**TOWN OF PLYMOUTH
PLYMOUTH MUNICIPAL AIRPORT**

RECONSTRUCT RUNWAY 6-24, RECONSTRUCT TAXIWAY H, J, K AND L

ADDENDUM No. 1

Date: April 16, 2026

SHEET NUMBER
S2.5

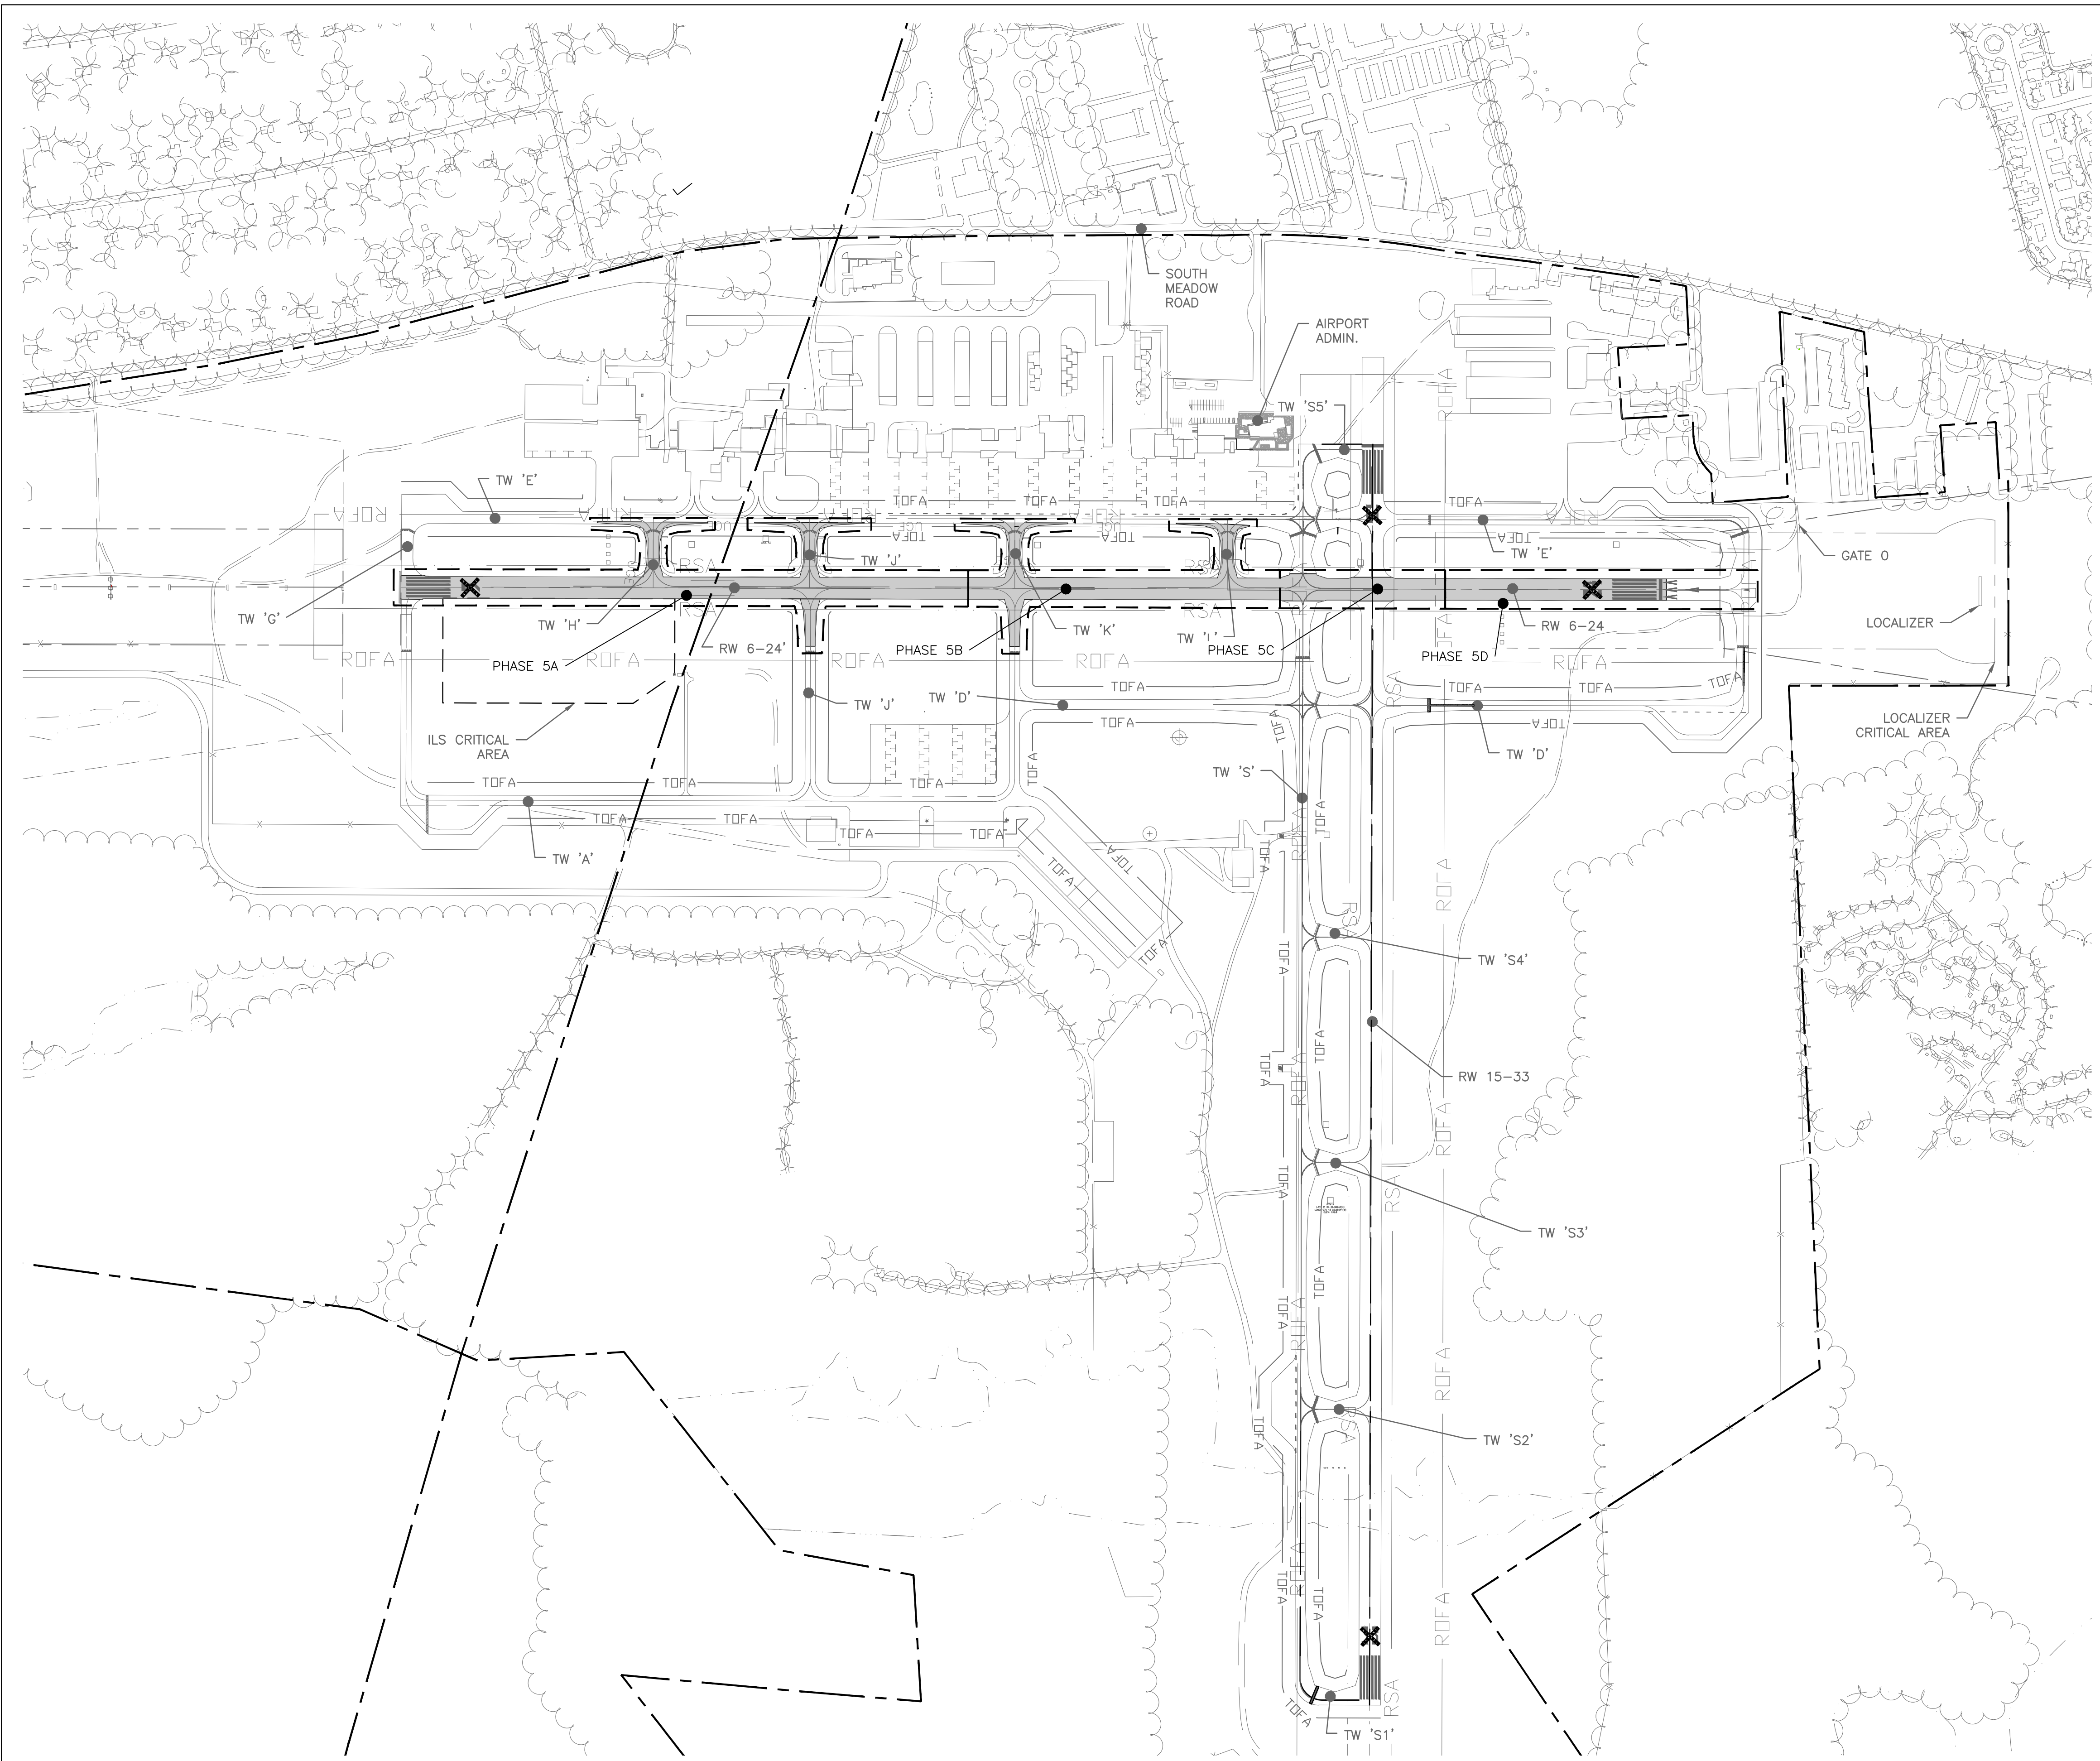
G1.5 Quantities:	Sheet has been revised. See revised sheet.
S2.5 CSPP 5 Phasing Plan:	Sheet has been revised. See revised sheet.

1. PERFORM RUNWAY GROOVING OPERATIONS.
2. INSTALL PERMANENT PAVEMENT MARKINGS.

1. CONSTRUCTION OF WORK AREA INCLUDES:
 - RUNWAY GROOVING AND MARKING OPERATIONS.
2. CONSTRUCTION ACTIVITIES ARE RESTRICTED TO BETWEEN 7:00 AM AND 7:00 PM MONDAY THROUGH SATURDAY. NO CONSTRUCTION MAY BE PERFORMED ON SUNDAY.
3. WORK AREA 5A MAY BE WORKED ON CONCURRENTLY WITH WORK AREA 1, 4 AND 5D.
4. WORK AREA 5A MAY NOT BE WORKED ON CONCURRENTLY WITH BOTH WORK AREAS 2, 3, 5B AND 5C.
5. WORK AREA 5B MAY NOT BE WORKED ON CONCURRENTLY WITH WORK AREA 1, 3, 4, 5A, 5C, OR 5D.
6. WORK AREA 5C MAY BE WORKED ON CONCURRENTLY WITH WORK AREA 3, 4, AND 5D.
7. WORK AREA 5C MAY NOT BE WORKED ON CONCURRENTLY WITH WORK AREAS 1, 2, 5A, OR 5B.
8. WORK AREA 5D MAY BE WORKED ON CONCURRENTLY WITH WORK AREAS 1, 3, 5A OR 5C.
9. WORK AREA 5D MAY NOT BE WORKED ON CONCURRENTLY WITH WORK AREAS 2 OR 5B.
